APPLICATION FOR CERTIFICATE OF APPROPRIATENESS

224 Leonard Place 37917

Staff Report

File Number: 7-A-21-HZ

Front door proposed product.

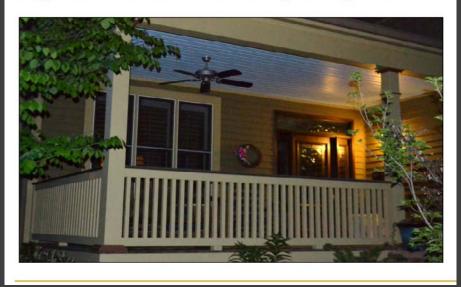
We will be installing a new front door to match the historic craftsman style that is seen on much of the street.

All wood door with glass pane.

- 3. The leftmost half-light wood door is not original to the house; it was also installed in 2006 (1-B-06-HZ). Replacing the existing non-historic doors with new wood half-light doors meets the design guidelines. While a half-light door with a single pane instead of a multi-light configuration is more appropriate for a Folk Victorian style house, the proposed doors are compatible in size, scale, and material with the original house. Moreover, the doors will be minimally visible from the right-of-way as one is significantly recessed from the sidewalk and elevated on the porch, and the second door is perpendicular to the façade.
